## REQUEST

Current Zoning: R-3 (single family residential)  
Proposed Zoning: MUDD-O (mixed use development, optional) and NS (neighborhood services) with five-year vested rights

Approximately 16.23 acres on the east side of Steele Creek Road and south of Rigsby Road, across from Shopton Road West and Dixie River Road.  
(Council District 3 - Mayfield)

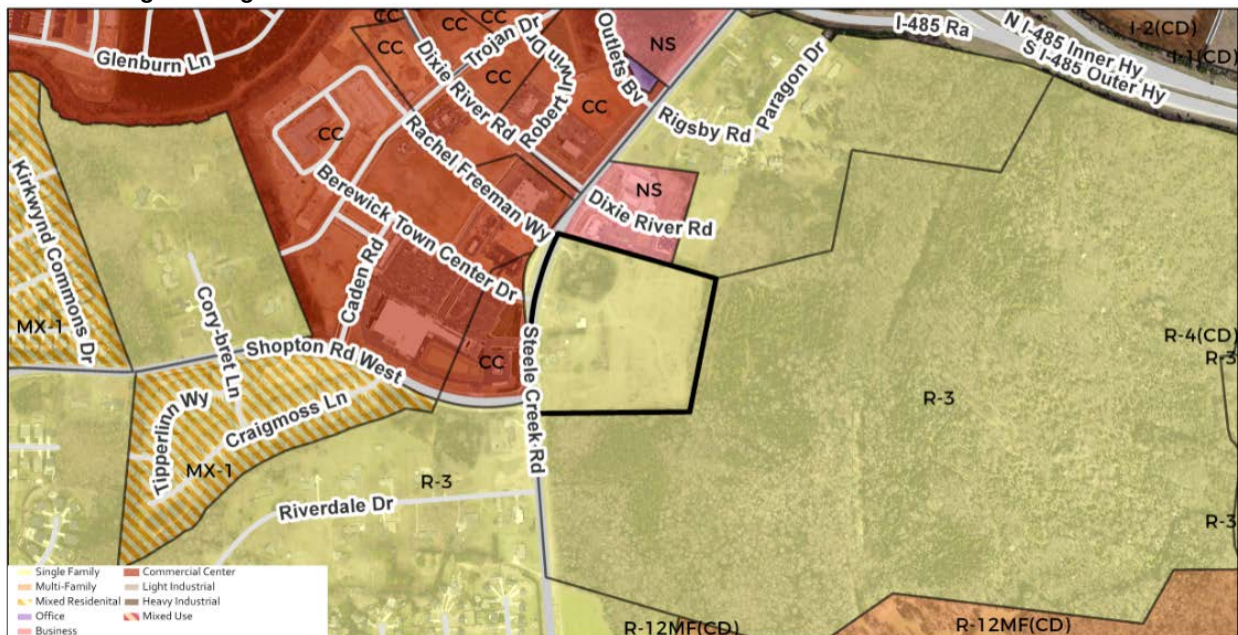
1. Revise site plan to show proposed Shopton Rd West built as a three lane road with buffered bike lanes (three-foot buffer, five-foot bike lane), eight-foot planting strip, and six-foot sidewalk.

2. Revise the site plan and conditional notes for proposed Private Street A
  - a. Convert to a public street connection between Dixie River Rd and Shopton Road West, which are both public thoroughfares.

- b. Extend right-of-way to the southern property line (south of Shopton) to allow the street to be extended in the future as the property to the south develops. Show the full road cross section and right-of-way extending to the southern property line.

3. Revise the site plan and conditional notes for Private Street B.
  - a. Convert to a public street connection or provide a public access easement and commit to cross connection to adjacent parcel when developed.

4. Revise the site plan and remove the pedestrian island/sweeping right condition shown at the intersection of Shopton Road West and Private Street A. CDOT does not support this type of intersection geometry. The intersection design will be reviewed during the permitting process and should not be a part of the rezoning.

5. Revise the site plan and conditional notes to show dedication of right-of-way, fee simple, 75 feet from centerline of Steele Creek Road to accommodate the future widening.

8. Along the east property line where the 30-foot setback is noted adjacent the MUDD Development Area, please note or depict that a sidewalk with street trees will be planted as an interim condition until a street is constructed. Ground floor entrances will connect to this sidewalk.

9. Under Design Guidelines Note VI.a.2. the proposed building should occupy a minimum of 60% of this frontage area.
10. Clarify Design Guidelines Note VI.a.12.

11. Under Design Guidelines Note VI.b.1., provide a minimum of 30% preferred exterior building materials (not 10%) or remove the note completely.
12. Remove Note 5 under Design Standards related to Residential uses (MUDD Development Area).

13. Modify Design Guidelines Note VI.c.1.C. to state facades fronting primary fronting areas will have minimum of 50% of each frontage elevation glass, with up to 20% non-reflective spandrel, film or display windows. Modify Design Guidelines Note VI.c.1.E. to add expanses of blank walls will not exceed 20 feet in length.

14. Open spaces have not been noted on the rezoning plan as stated in Open Space and Amenity Areas Note VIII.a.
15. Modify Design Standards Note VI.b.9. to state that if structured parking is developed, exposed multi-level parking decks will provide screening so that interior lighting and cars are not visible from public or private streets

16. The petitioner is requesting MUDD-O, but no optional provisions are identified on the site plan.
  17. Remove the request for more than one drive-through service window as an accessory to a neighborhood food and beverage service as the drive through for this use is not permitted by ordinance in the NS (neighborhood service) district.
  18. Reference Section 6.207 from the Zoning Ordinance on the site plan.  
Proposed 25-foot landscape area along Steele Creek Road needs to be better labeled on the site plan.
-
